From: Derek Luby [mailto:dluby@slrconsulting.com] Sent: 02 February 2017 10:31 To: Ewa Babiarczyk Subject: Roadstone Huntstown - Waste Licence Review Application - Grid Co-ordinates for GW4

Further to your Article 12 compliance request in respect for the waste licence review application in respect of the soil waste recovery facility at Huntstown Quarry (Ref. W0277-02), can you please clarify for me, the precise concerns you have in respect of the location / position of groundwater monitoring well GW4.

Location of GW4 - immediately inside Roadstone boundary (neighbouring property to west / left of photo)

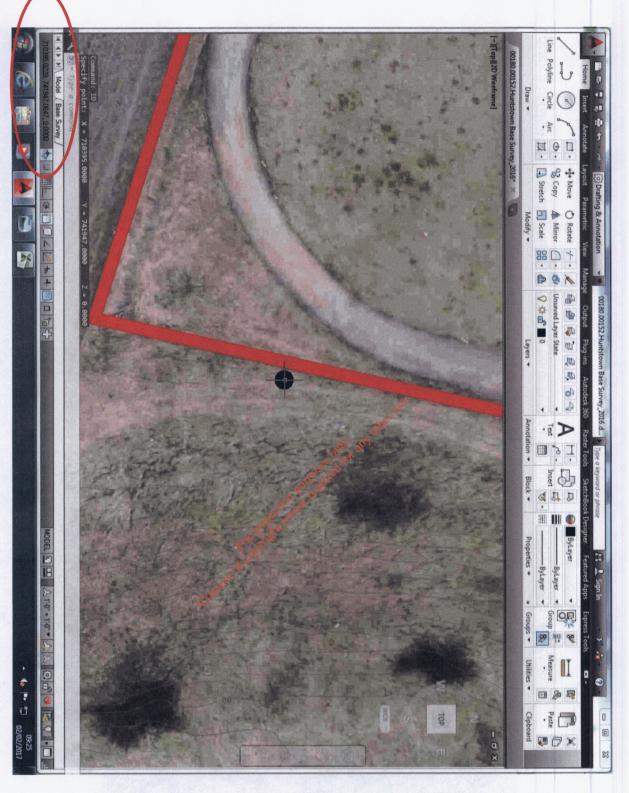
We have checked the grid co-ordinates on an ortho-rectified ITM grid-referenced aerial photograph obtained from a site (drone) survey and find that the co-ordinates advised for GW04 in Attachment F5 (ie. 710395E and 741947N) are correct and lie within the application site boundary - refer to screen grab attached.

Separately, we have provided a ground level photograph which clearly shows that monitoring well GW04 is located immediately inside the Roadstone boundary, at a location consistent with that indicated on the aerial photograph / screen grab.

We recognise that the monitoring well symbol used on some drawings supplied with the EIS / licence review application might suggest that the well straddles the site boundary between Roadstone and the property to the west. This is not the case in reality - the well symbol is drawn at an exaggerated scale solely for ease of identification / visualisation - although it should be centred at the grid -coordinates provided.
